Assembly method change for Hood, Front Weather Strip, & Grill

AFFECTED VEHICLE: 2022 Outlander

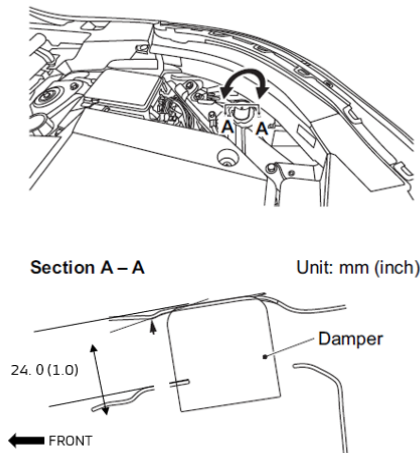
For vehicles that may continue to exhibit hood fluttering, the hood should be replaced with a new hood where reinforcement has been added (65100W060P or 65100W080P).

A change in the weather strip from a full clip style attachment to a new style which requires installation over the front lip of the hood, has also been made. The new weather strip (65820W010P or 65820W020P) should be installed prior to re-installation of the grill (from original hood).

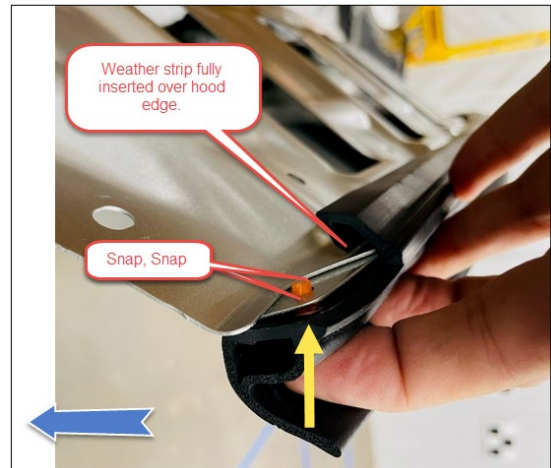
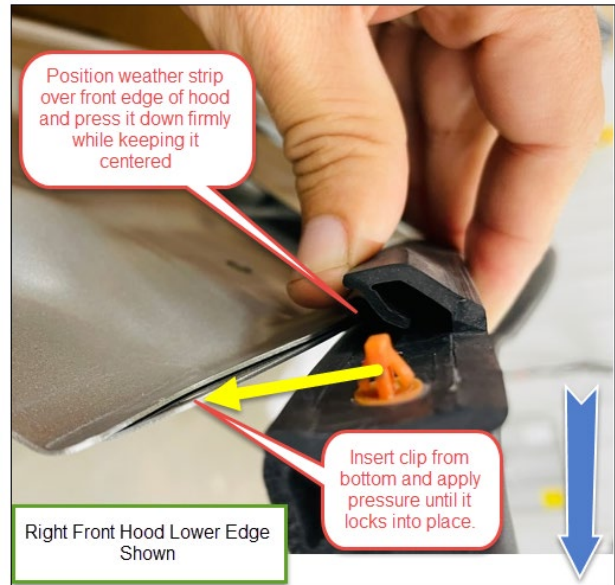
1. Install front weather strip.
2. Install and secure grill with 11 mounting bolts (reuse grill from original hood).

FINAL INSPECTION

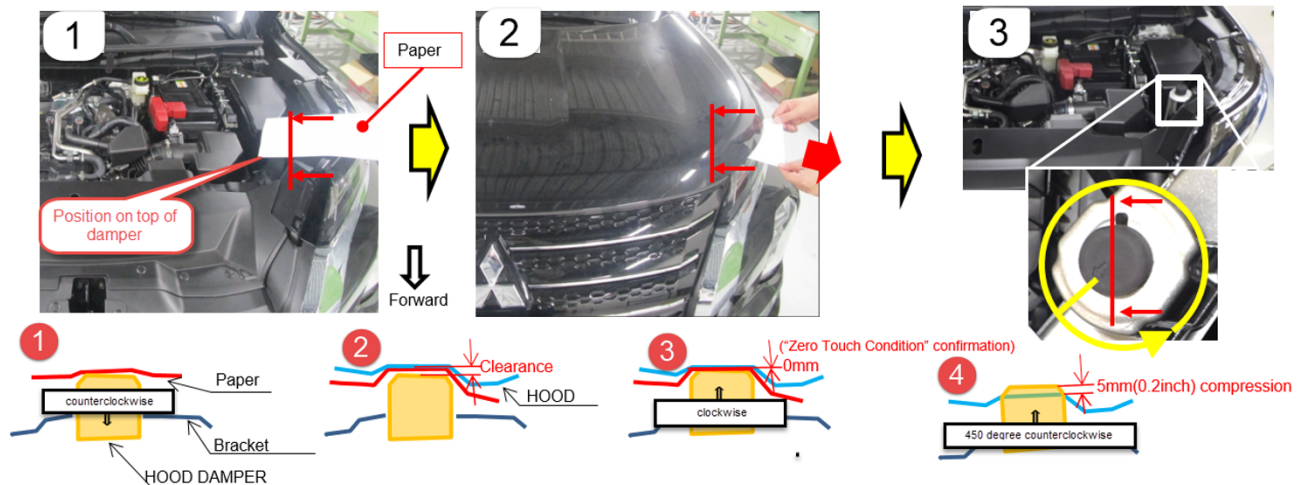
- Insert standard printer paper with one corner of the paper between the damper and hood
- Close hood and attempt to pull paper out from between the damper and hood
 - If the paper tears:
 - Turn the damper clockwise $\frac{1}{4}$ turn at a time until the paper pulls out with moderate drag but without tearing paper
 - If the paper pulls out easily:
 - Turn damper $\frac{1}{4}$ turn counterclockwise until paper tears when attempting to pull it out
 - Then turn clockwise $\frac{1}{4}$ turn until moderate drag is achieved without tearing paper
 - Final adjustment
 - Create 5mm compression by doing a final turn of each damper 450 degrees counterclockwise
